APPENDIX D-2
Sea Level Rise Technical Memo

MEMORANDUM

To: Matt Fennig, Vallejo Marine Terminal
From: Neil Nichols, Christopher Devick, Dilip Trivedi
Date: March 12, 2015
Subject: Technical Memorandum
Sea Level Rise Assessment
M&N Project No: 8828

Figure 4: Proposed Platform Cross-Section

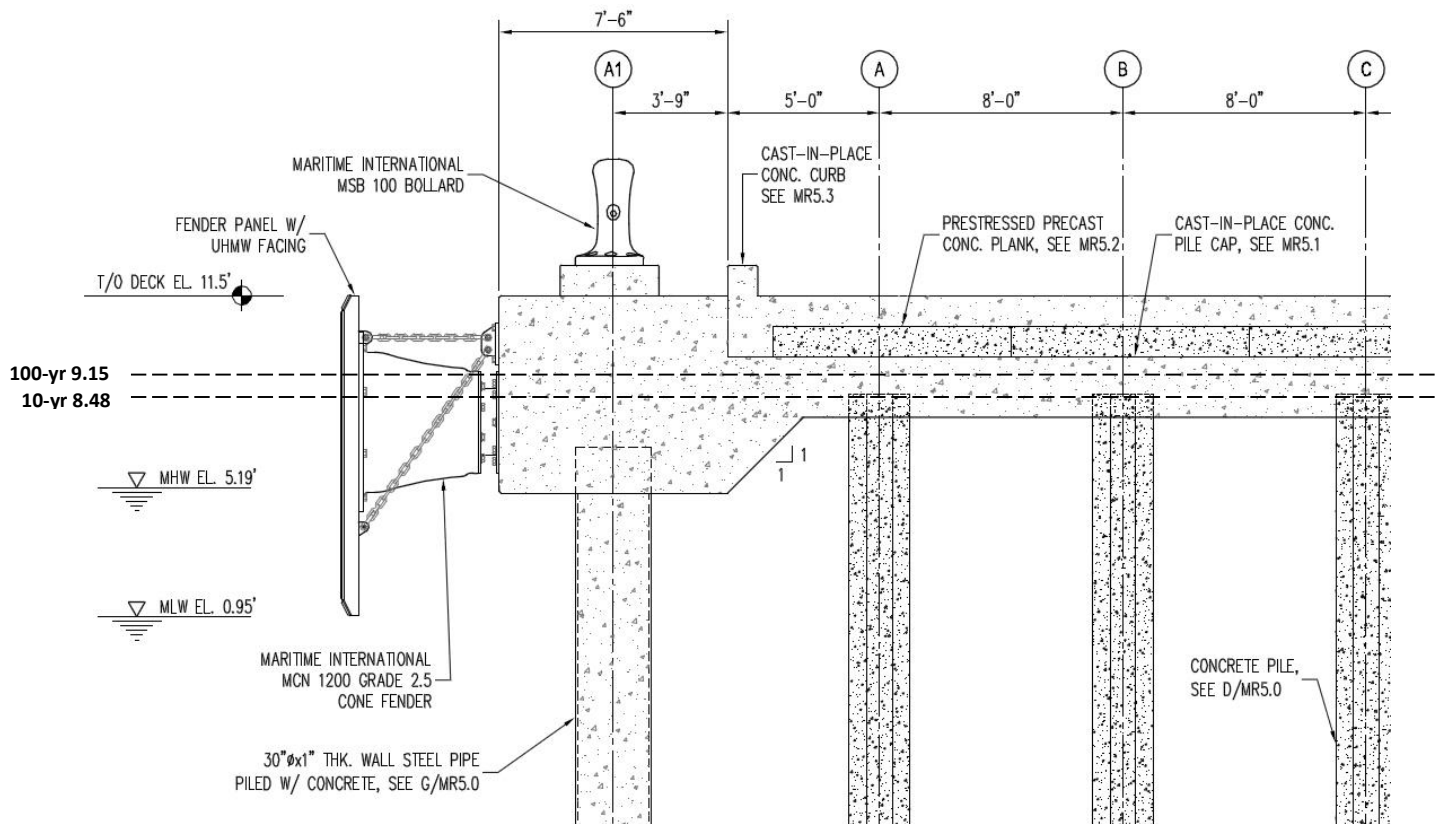
The drawings we reviewed (see **Figure 4⁶**) indicate a superstructure that has a 2' thick deck over 2' deep pile caps. The outer edge of the platform has a 6.5' deep beam supporting the fender system. Due to their depths, the edge beam and pile caps are both extending below the 100-yr WSEL, and may be subjected to buoyancy/uplift forces during extreme tidal events. The edge beam will be submerged daily by high tides, and eventually (after SLR occurs) the pile cap will be as well. These structural members should thus be designed to resist these loads and for continual salt water submergence.
